GWN76xx Firmware Release Notes

[04/05/2024] FIRMWARE VERSION 1.0.25.18

- Added **L2TPv3** tunnel support
- Internal bug fixes

- **Added L2TPv3 tunnel support.**

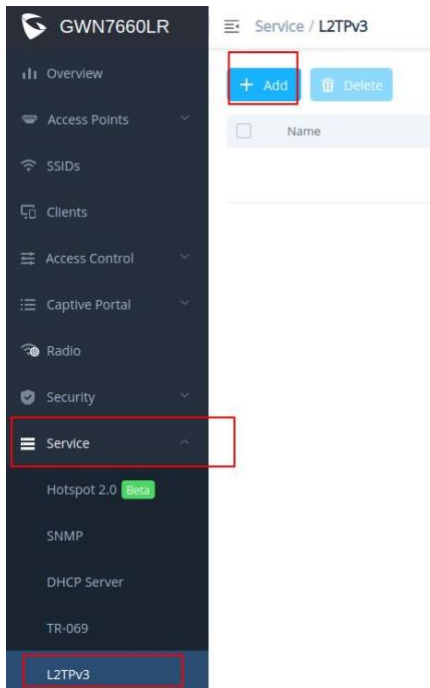
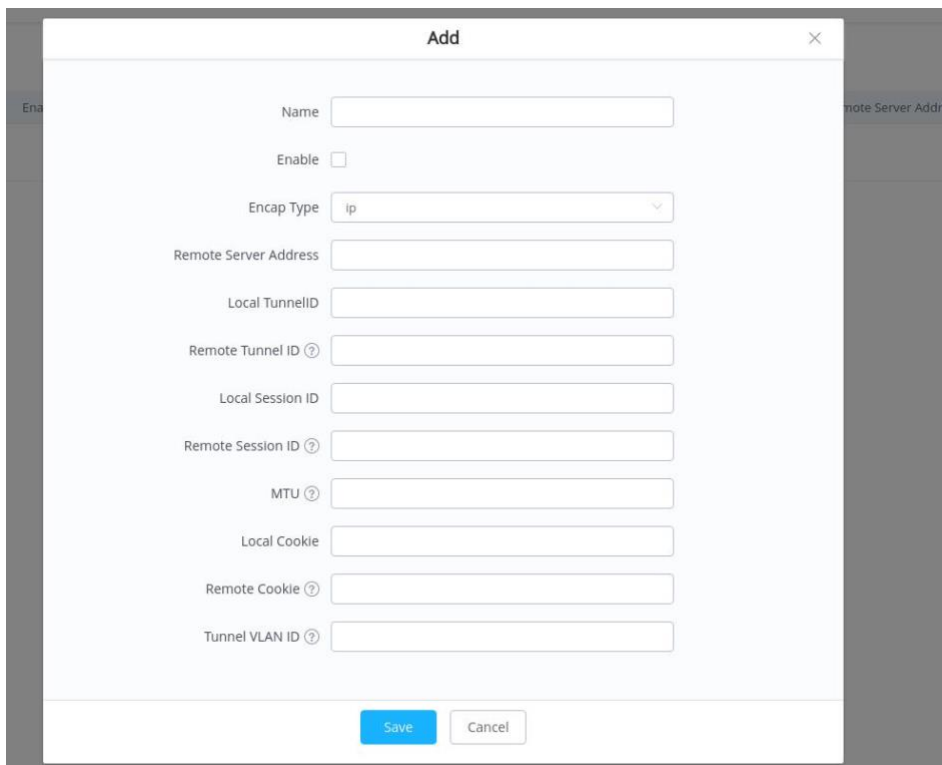
This feature will allow admins to enable and configure L2TPv3 on the device. Please refer to the screenshots and options below.

Note: It is best to set the MTU to match the server to avoid network connectivity issues.

- **Tunnel VLAN ID:** The tunnel ID must be set in SSID, and make sure that SSID only has the AP(s) who enabled L2TPv3.
